Subject: Duke Energy Corporation  
Oconee Nuclear Station - Units 1, 2, and 3  
Docket Nos. 50-269, 50-270, and 50-287

Revisions to Topical Report DPC-NE-3003 In Support of  
Steam Generator Replacement  
Response to NRC Staff Request for Additional  
Information

Enclosed herein, please find the Duke Energy Corporation (Duke) response to the May 12, 2003 NRC staff's request for additional information concerning topical report DPC-NE-3003, Revision 1, "Mass and Energy Release and Containment Response Methodology."

### **Duke Power Response To Request For Additional Information**

(14.1 ft<sup>2</sup> Break - RV Outlet - Low Initial RCS Flow w/ M3 Pump Degradation Model)

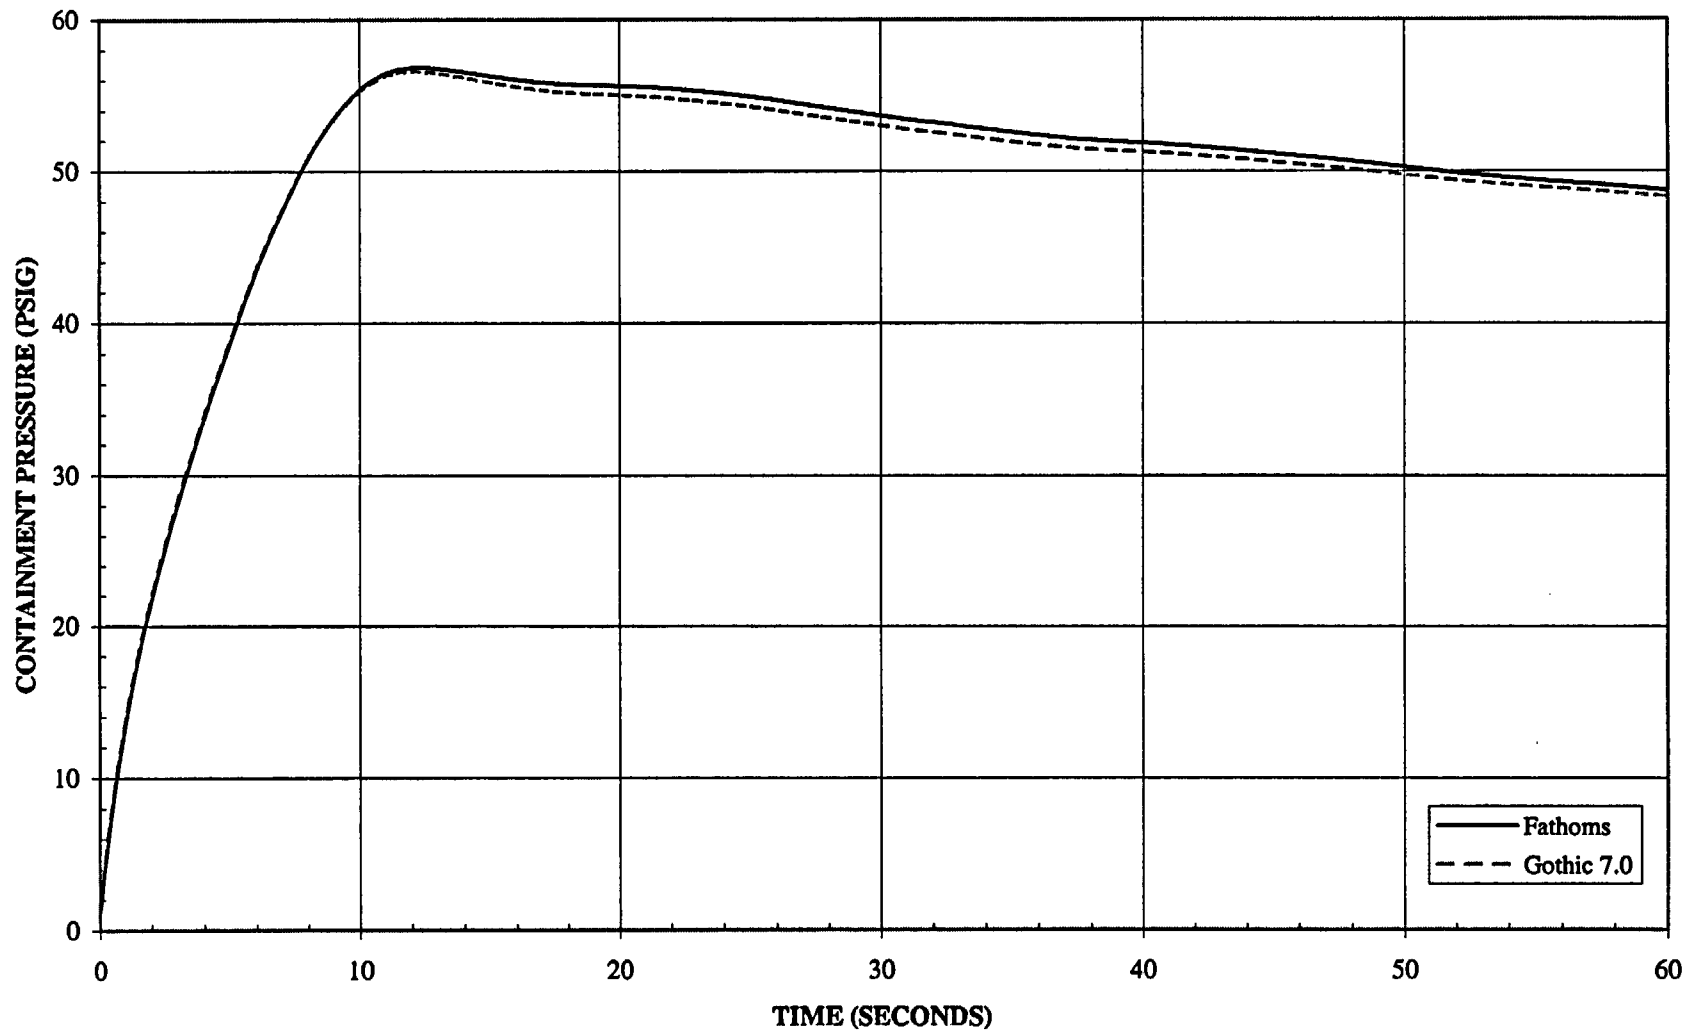
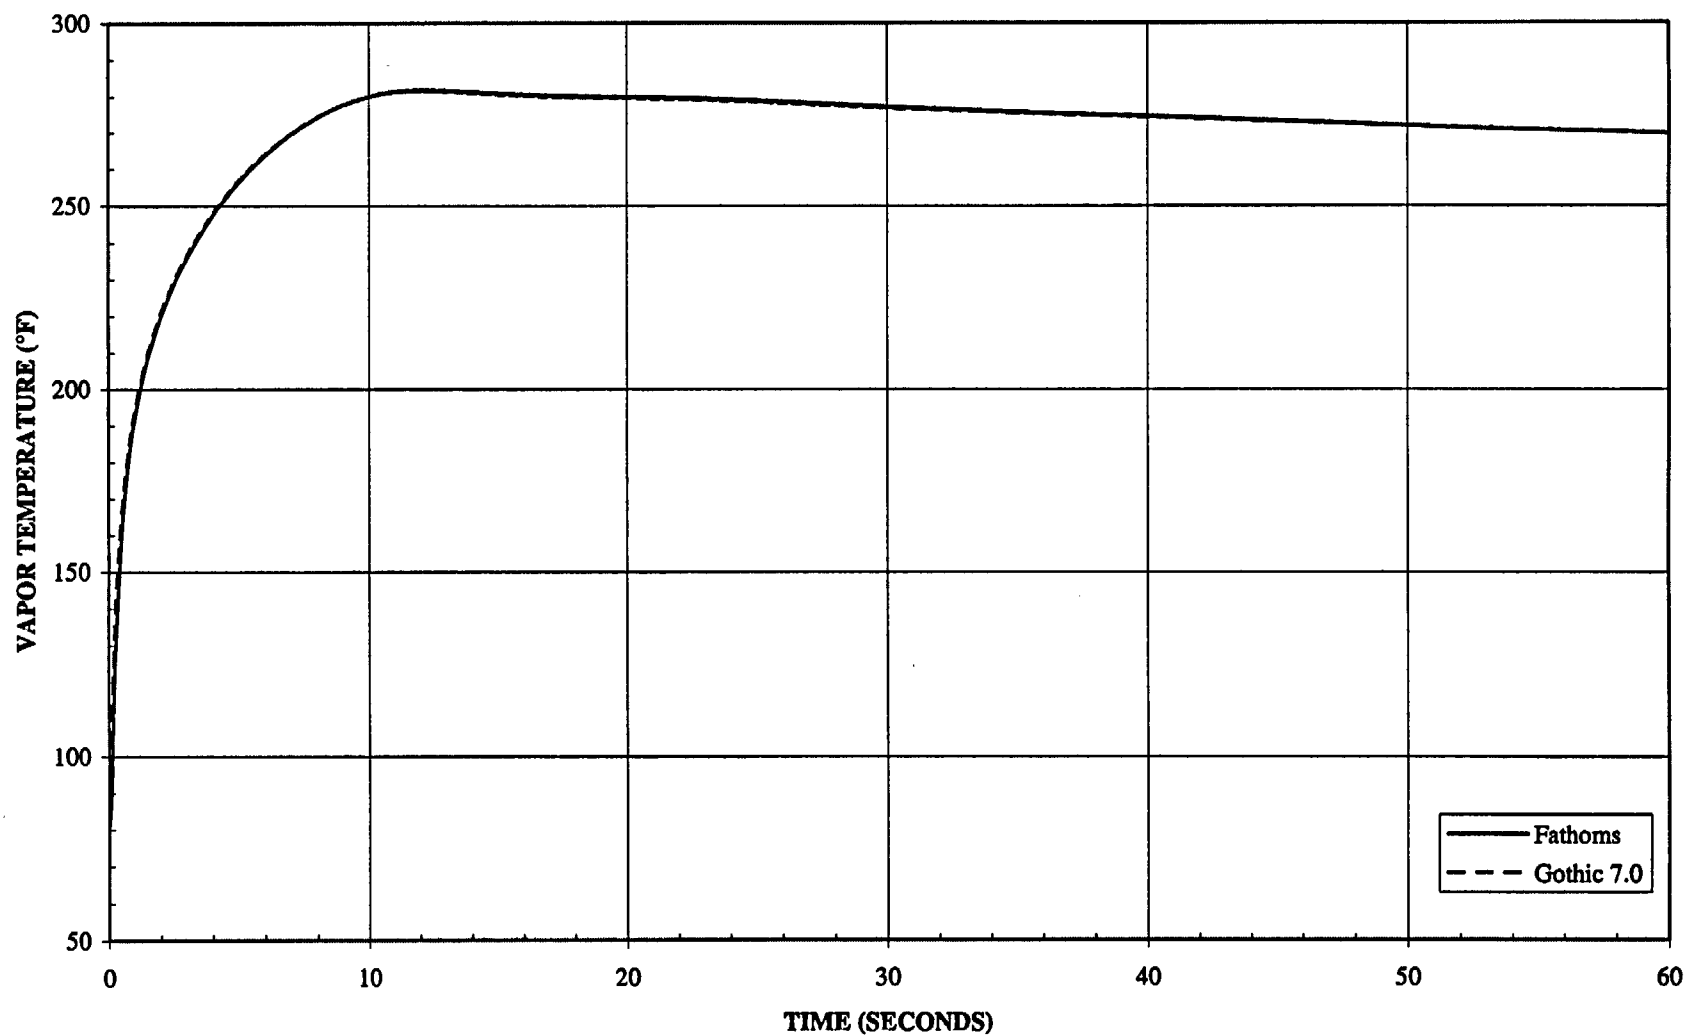
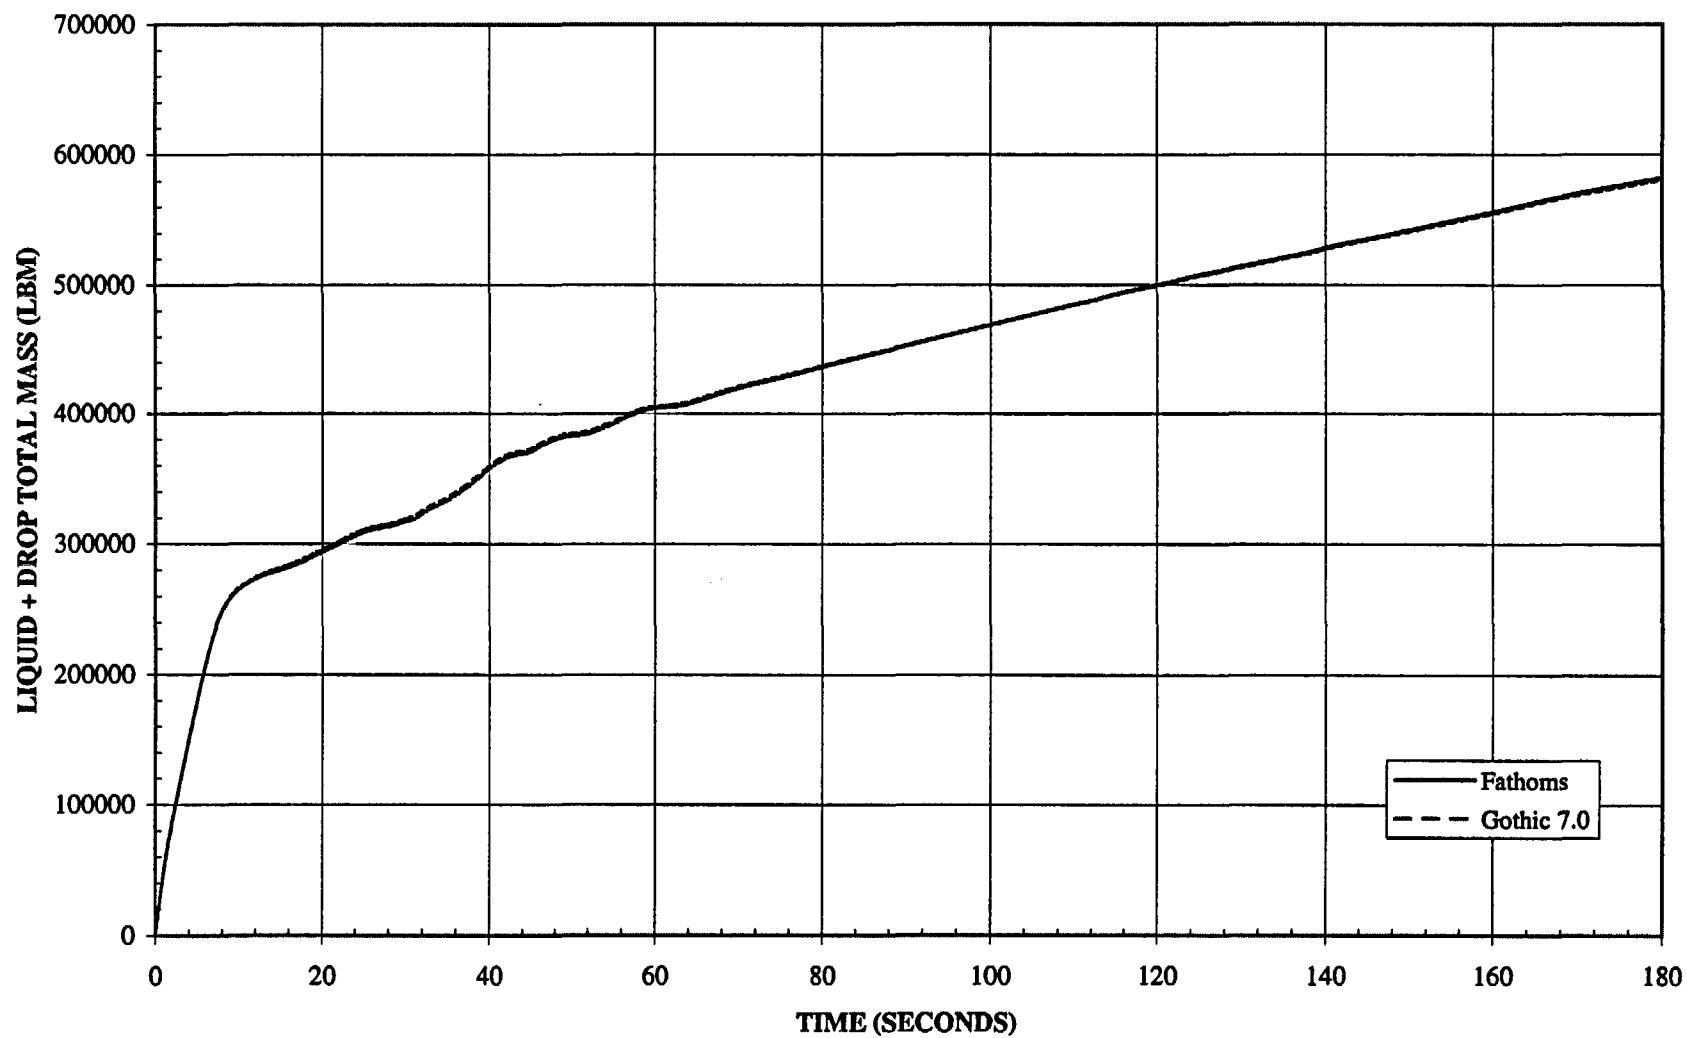
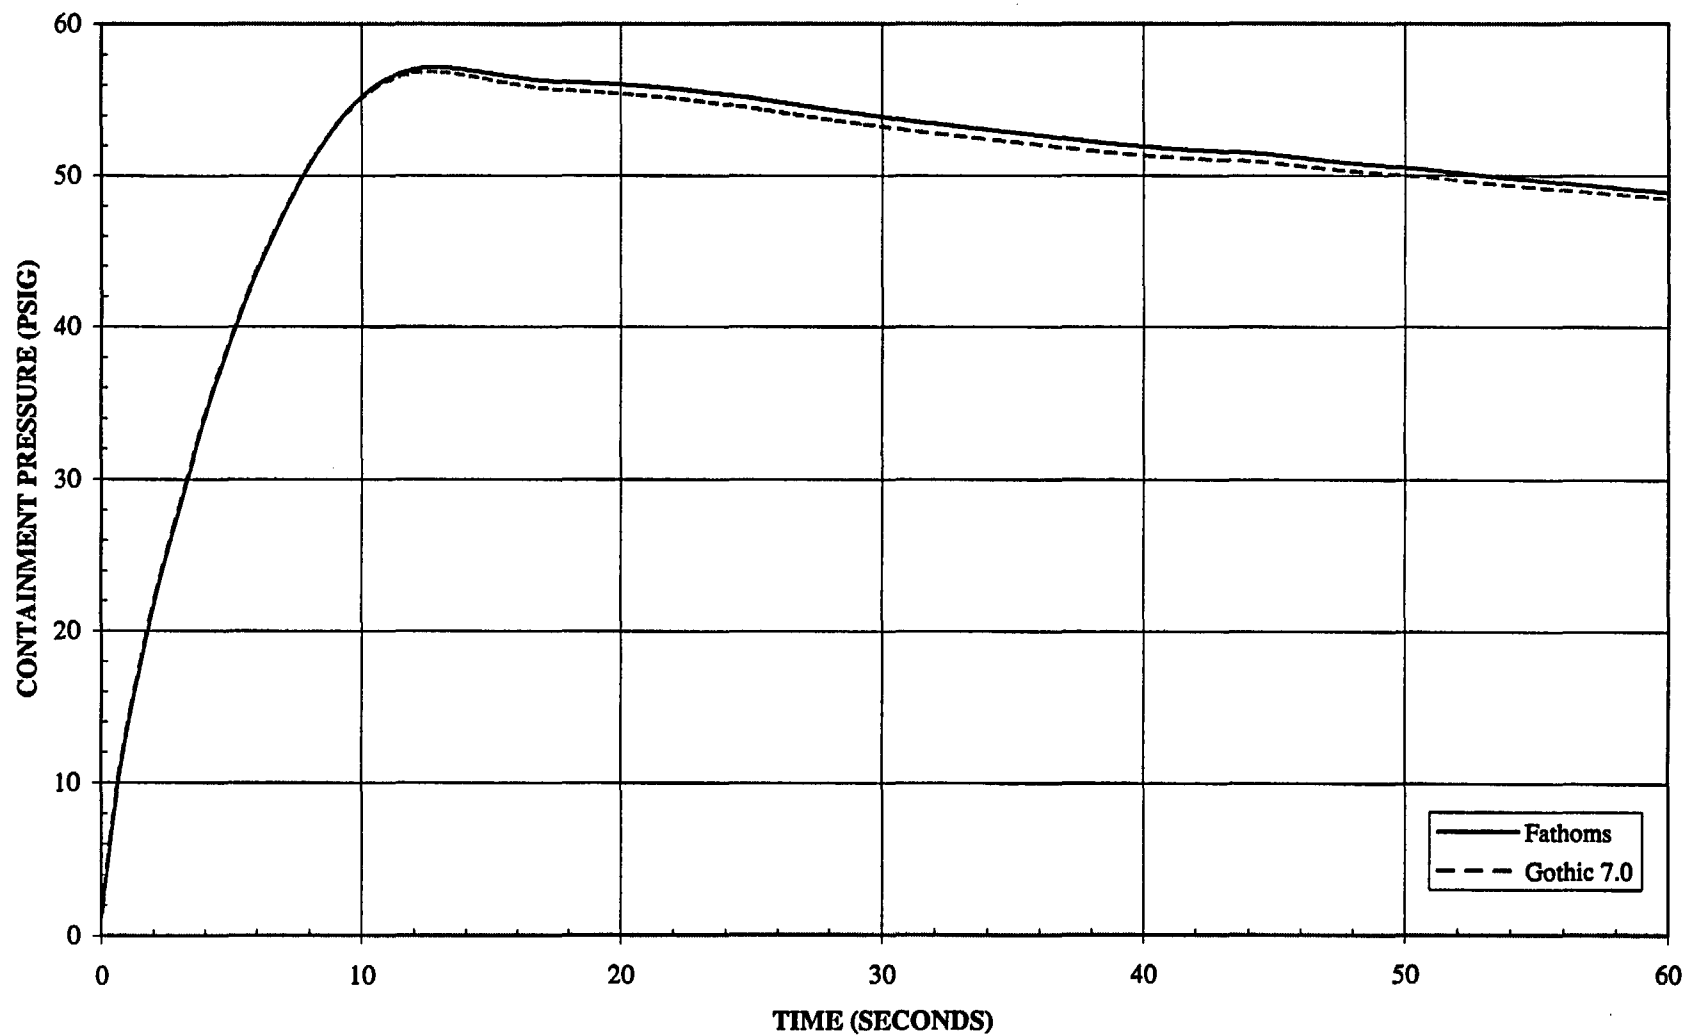
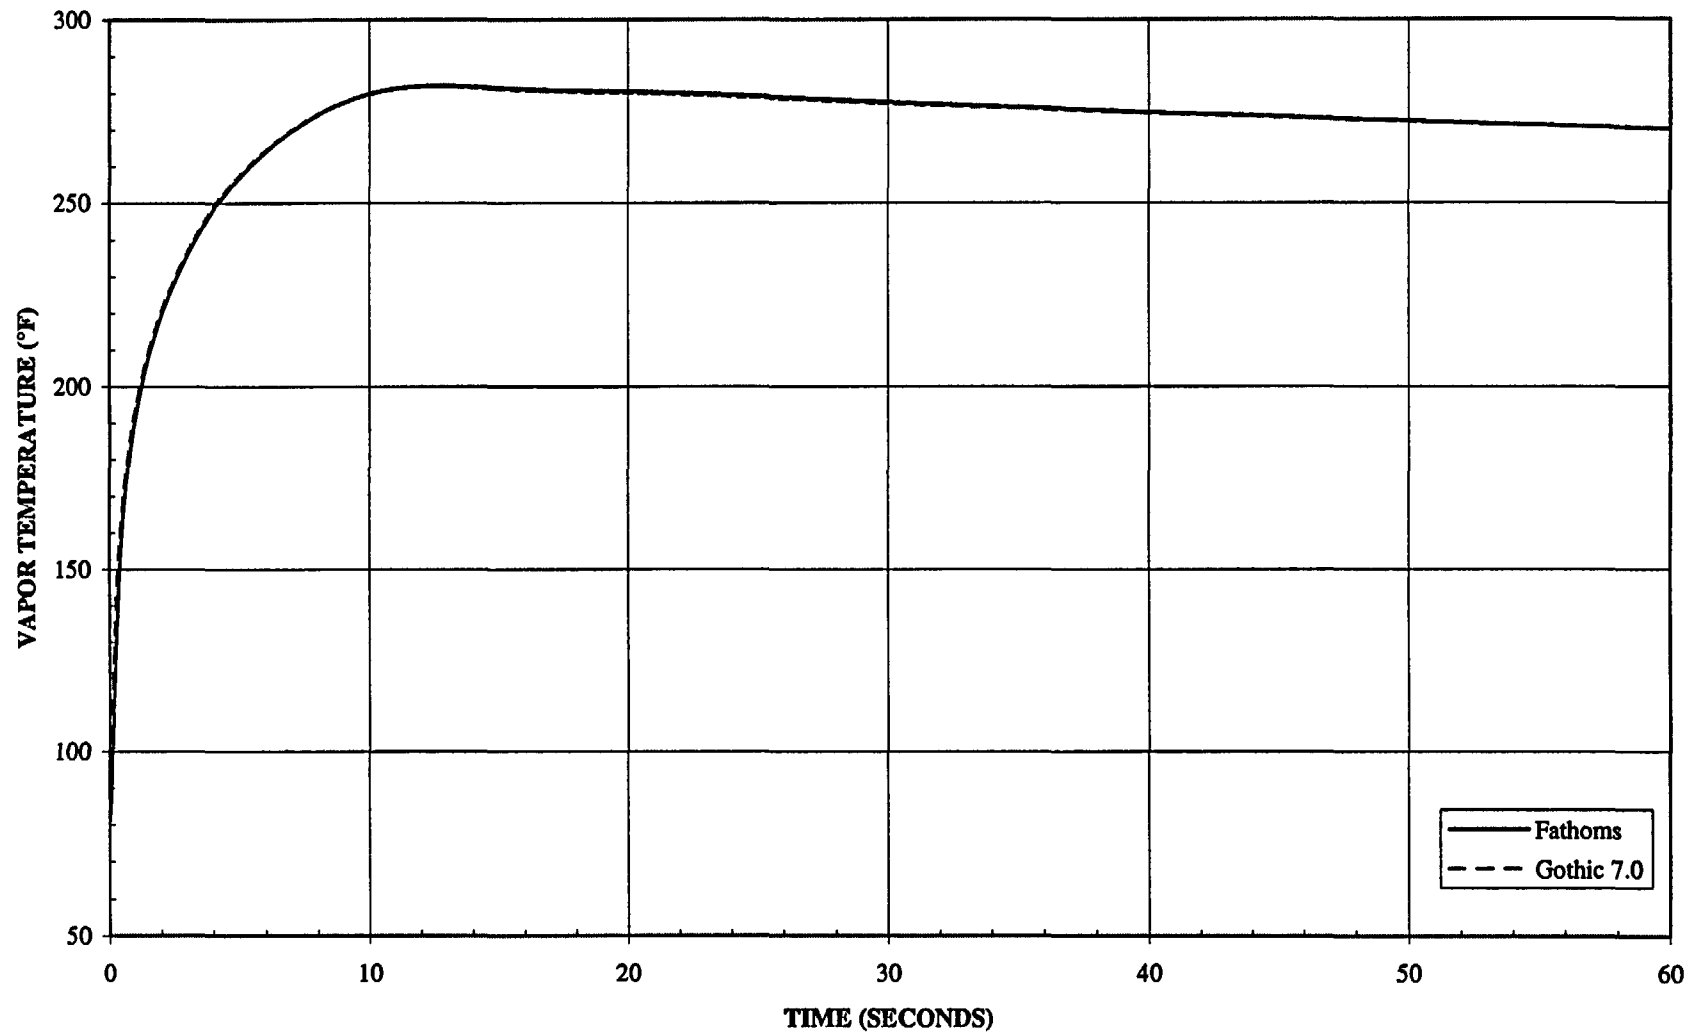
3. Please provide the results using the GOTHIC 7.0 code of peak pressure and temperature calculations for the sensitivity cases listed in Table 3.1-1 of DPC-NE-3003 in tabular and graphical form. If the results or conclusions are significantly different from those presented in DPC-NE-3003P, explain the difference.

Response: Table 3.1-1 of DPC-NE-3003 describes a spectrum of LOCA peak pressure cases including a range of break locations and sensitivity analyses for several important modeling assumptions. The staff's request is understood to focus on the difference in the predicted results from the FATHOMS and GOTHIC 7.0 code versions. Rather than show the comparison for the cases in Table 3.1-1, a different set of cases has been selected which is more focused on the current knowledge of the key sensitivity parameters. Also, the results presented are for the ROTSGs, which is the subject of Revision 1 to the topical report.

The results of the 14 code comparison analyses are shown in Table 3-1 below and in the figures that follow. In general, the pressure and vapor temperature response predictions were very similar in both magnitude and trend. GOTHIC 7.0 predictions for peak pressures and vapor temperature were slightly lower (~0.5 psig and 0.5°F). These differences are consistent with the code model differences described in the response to Question #1. Both codes predict a saturated containment atmosphere due to the large amount of drops injected. The slightly lower pressure, vapor temperature, and liquid temperature from GOTHIC 7.0 may be attributed to additional drop hold up in the atmosphere. This effectively increases the heat capacity of the atmosphere and reduces the temperature rise for a given energy addition. A comparison of the total liquid and drop masses, and liquid temperatures, show the predictions of the two codes to be essentially the same. This is consistent with the changes in the drop deposition and entrainment models discussed in Question #1. These results show that the two code versions give essentially similar results for the same break location and initial and boundary conditions.
